18077-01-001

**Proposed Residential Development at
Athgarvan, Co. Kildare**

ROAD SAFETY AUDIT STAGE 1

July 2018

CLIENT	KILDARE COUNTY COUNCIL
ARCHITECT	DEATON LYSAGHT ARCHITECTS
PROJECT	HOUSING UNITS IN ATHGARVAN VILLAGE, CO. KILDARE
TITLE	PROPOSED ENTRANCE SIGHTLINES

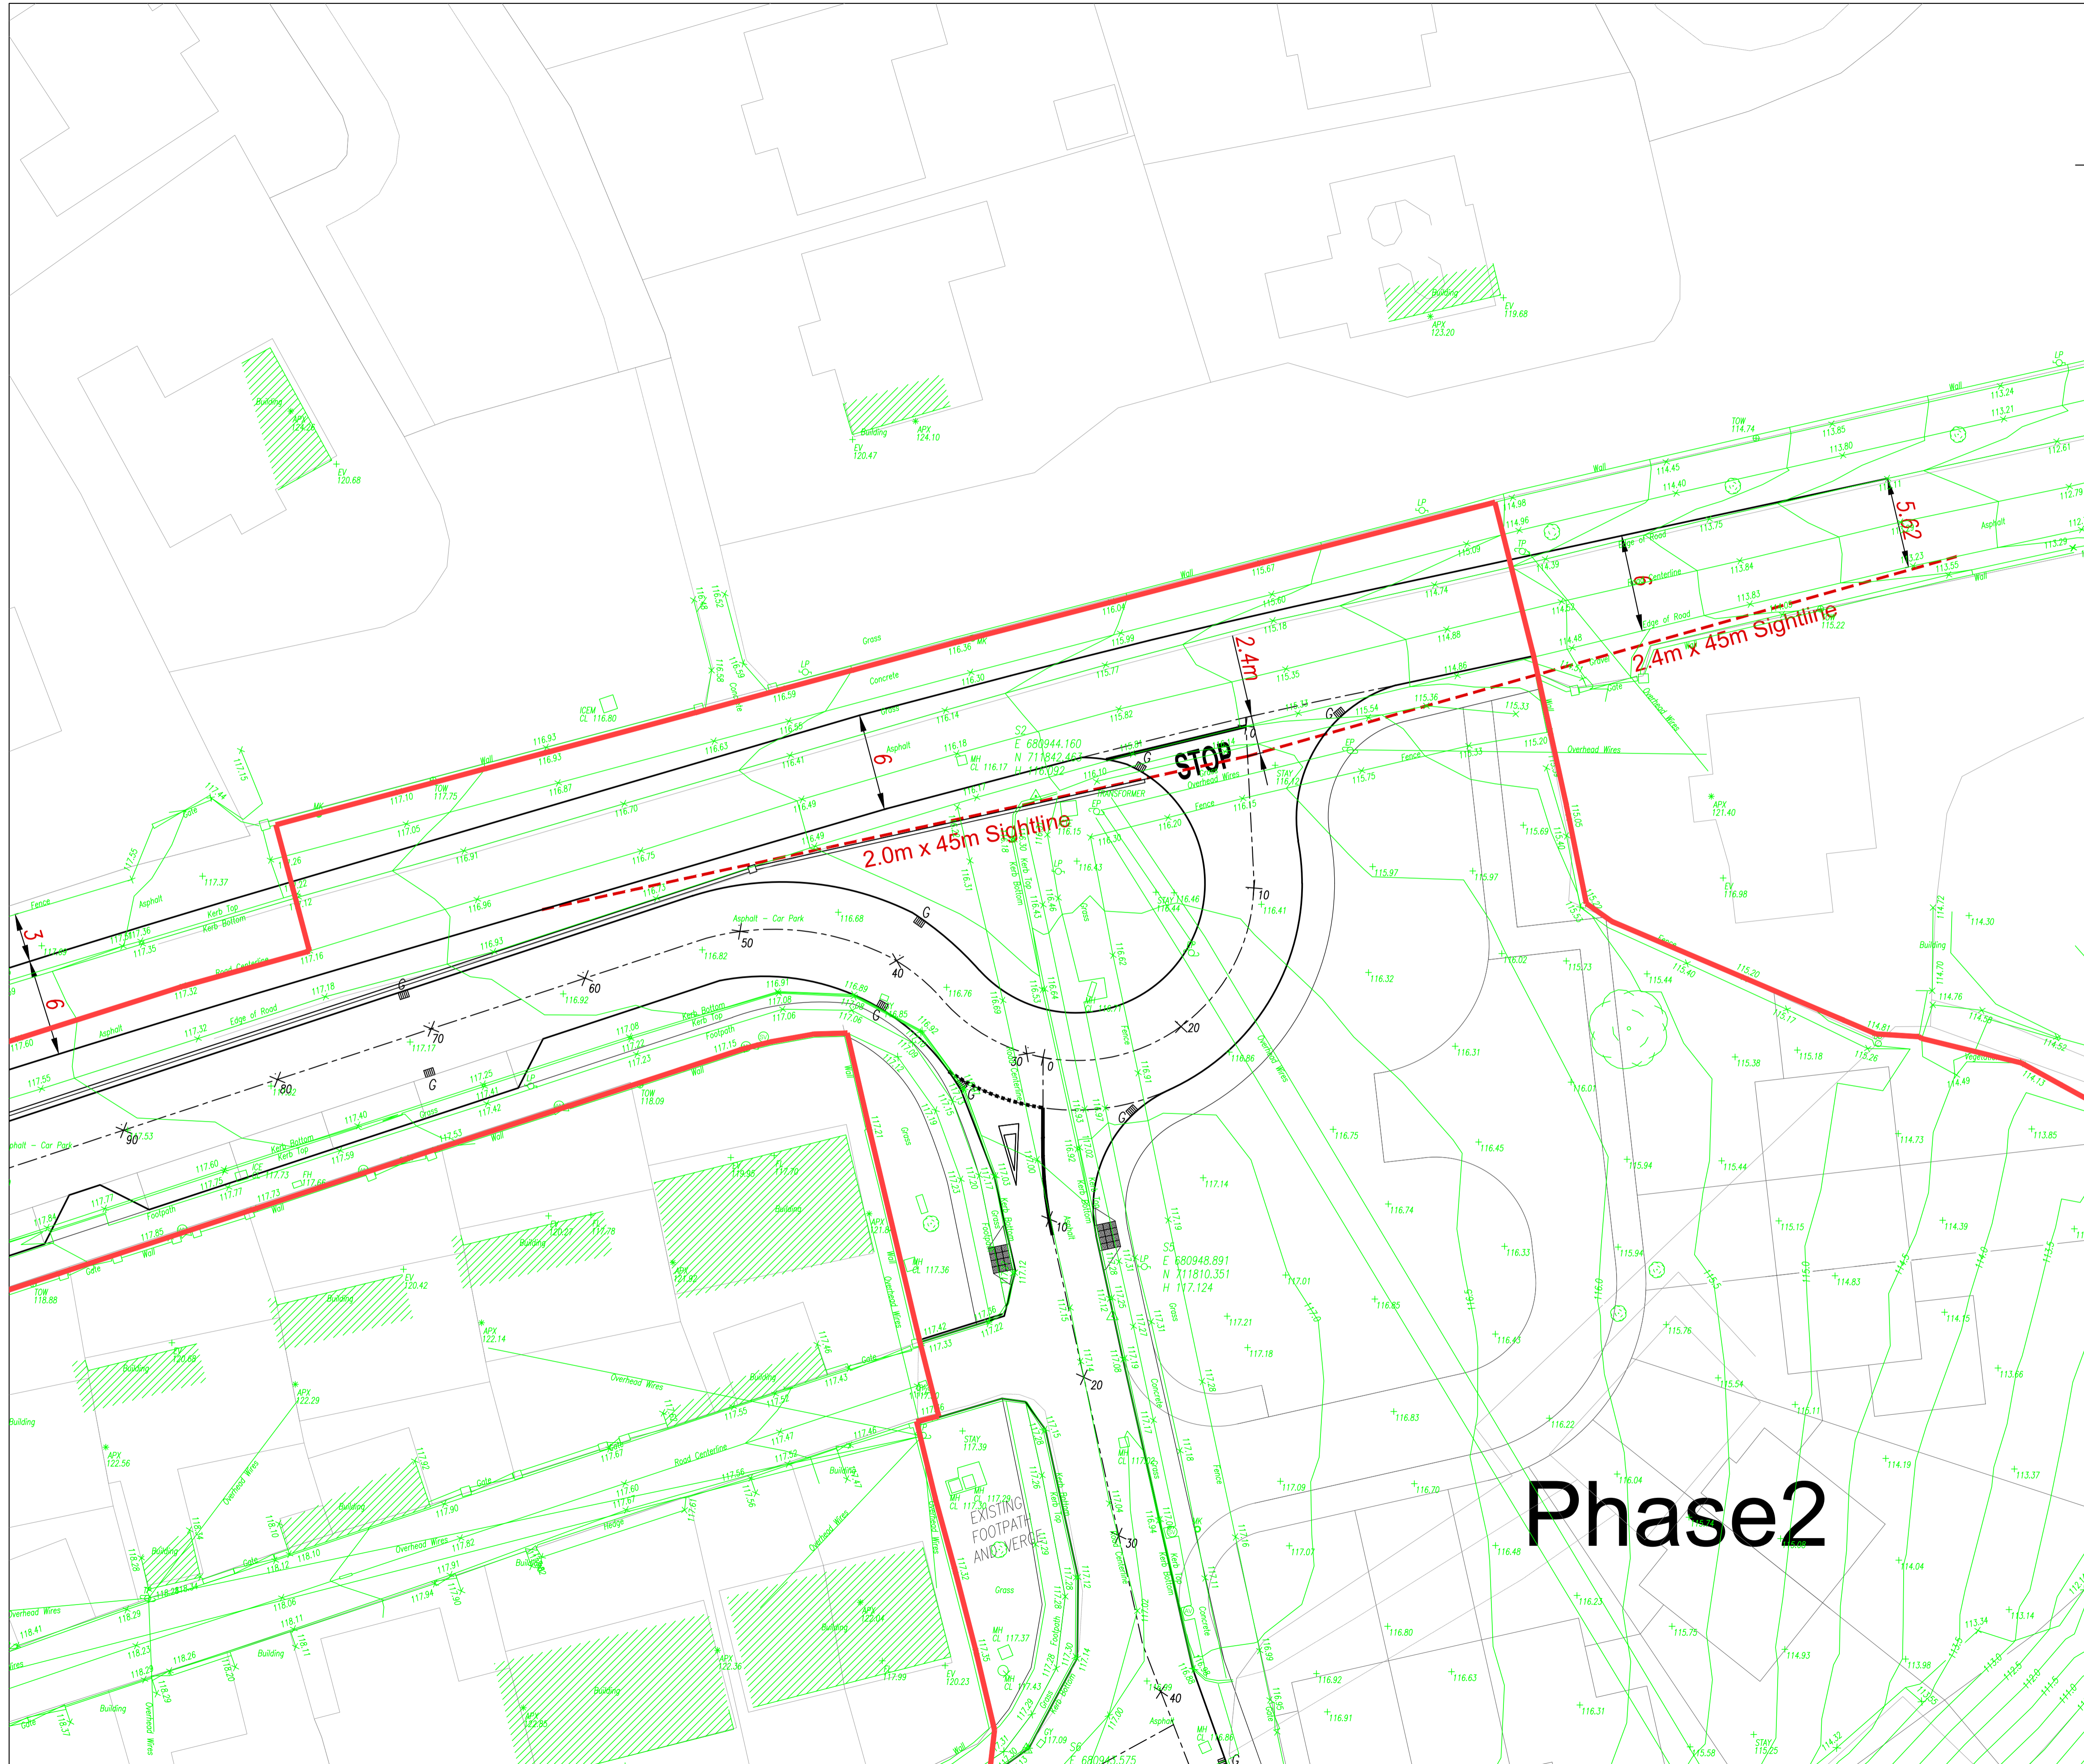
The sight distance at the entrance to the proposed housing scheme is constrained by an existing neighbouring boundary wall on the eastern side of the development.

- An 'x' distance of 2.0m may be tight at this location, particularly in light of proposing to move the existing southern road edge north of its current location in order to achieve visibility to the right.
- The taper from the existing to new road edge occurs through the junction mouth and as a result the proposed kerblines on the west side of the access may protrude out into the mainline carriageway.
- The taper lengths are short which results in an abrupt change in direction of the kerblines. This may lead to vehicles colliding with the kerblines.

Westbound drivers approaching the new junction may be following the existing road edge and may either collide with the new kerblines on the west side of the junction or a vehicle exiting the junction which is protruding onto the mainline in order to achieve adequate visibility of approaching vehicles.

A longer taper should be provided in advance of the junction, and a set-back of 2.4m for visibility splays should be provided at the access.

Paragraph No. In Safety Audit Report	To Be Completed By Designer			To Be Completed by Audit Team Leader
	Problem accepted (yes/no)	Recommended measure accepted (yes/no)	Describe alternative measure(s). Give reasons for not accepting recommended measure	Alternative measures or reasons accepted by auditors (yes/no)
2.1	Yes	Yes – drawing has been revised as per the recommendations. See attached Drg. 17-091-P002B and 17-091-P005B.	—	—
2.2	Yes	Yes – uncontrolled pedestrian crossings have been added at each end of the development.	—	—
2.3	Yes	Yes – parking bays have been relocated to the southern side of the access road.	—	—
2.4	Yes	Yes – the road re-alignment has been adjusted to maintain the existing footpath width in the narrow section.	—	—
2.5	Yes	Yes – public lighting to be included at detailed design stage as per the recommendations.	—	—
